Rezoning Application: PD 26-0217**Zoning Hearing Master Date:** May 26, 2026**BOCC Land Use Meeting Date:** July 21, 2026**Hillsborough
County Florida****Development Services Department****1.0 APPLICATION SUMMARY**

APPLICATION NUMBER: PD 26-0217

AGENCY REVIEW COMMENT SHEET

TD-9

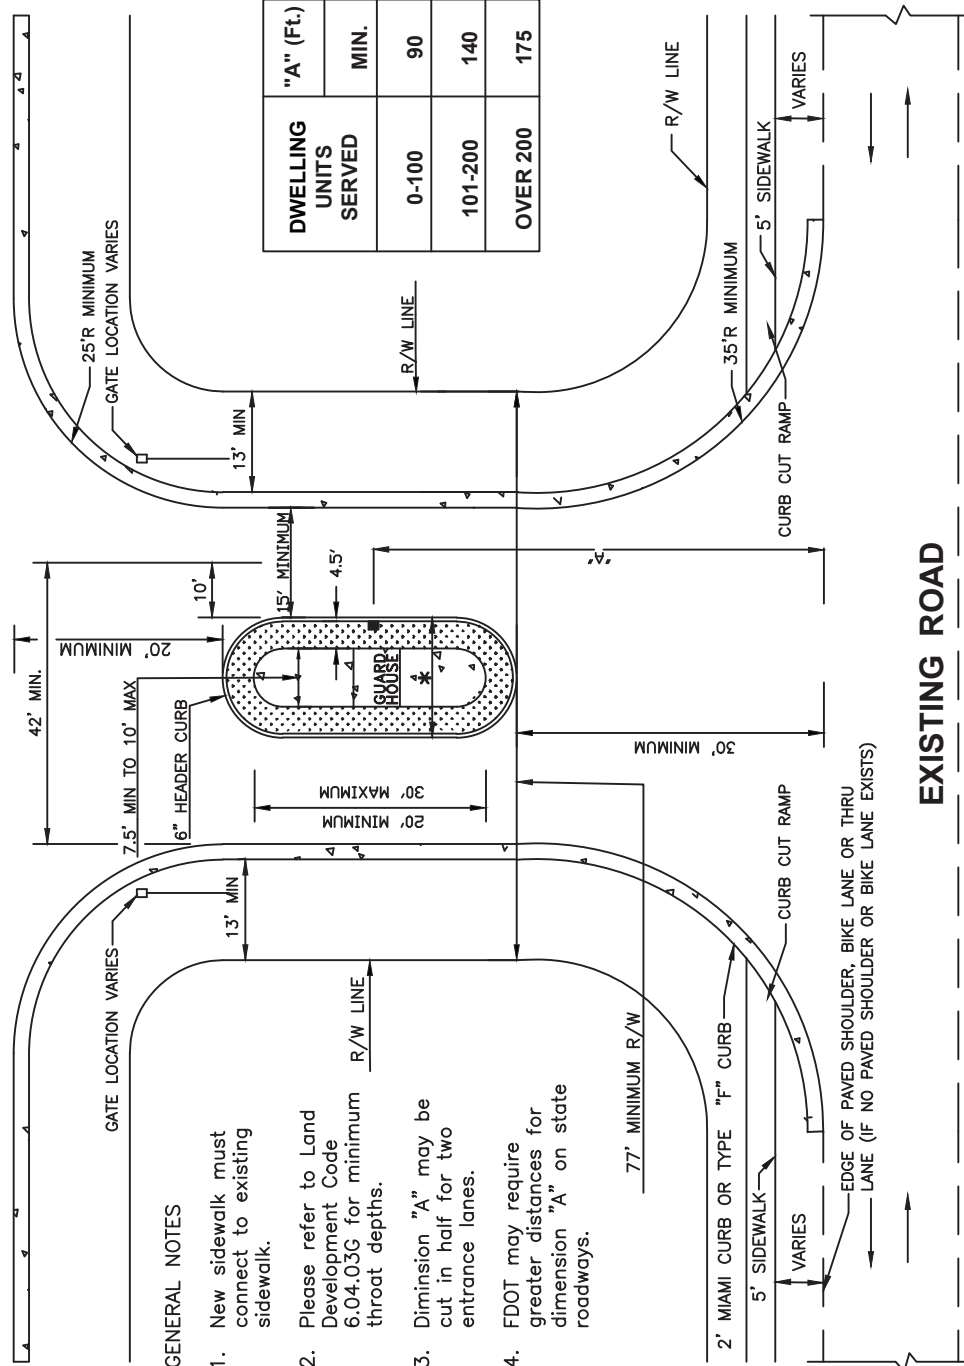
REQUESTED DESIGN EXCPETION – TYPICAL DETAIL – 9 (TD-9)

The developer is proposing to develop a gated access to Autumn Ridge Ave., which is required to comply with TD-9 standards as found within the Transportation Technical Manual (TTM). The applicant's Engineer of Record (EOR) submitted a Design Exception request (dated April 30, 2026) to propose/determine the alternate improvements that would be required by the County Engineer. Based on factors presented in the Design Exception request, the County Engineer found the request approvable (on May 11, 2026). The deviations from the TTM TD-9 include that the developer shall be permitted to provide 80 feet of gate queue in a single-entry lane configuration, rather than the up to 175 feet of queue that is required in a single-entry lane configuration per TD-9.
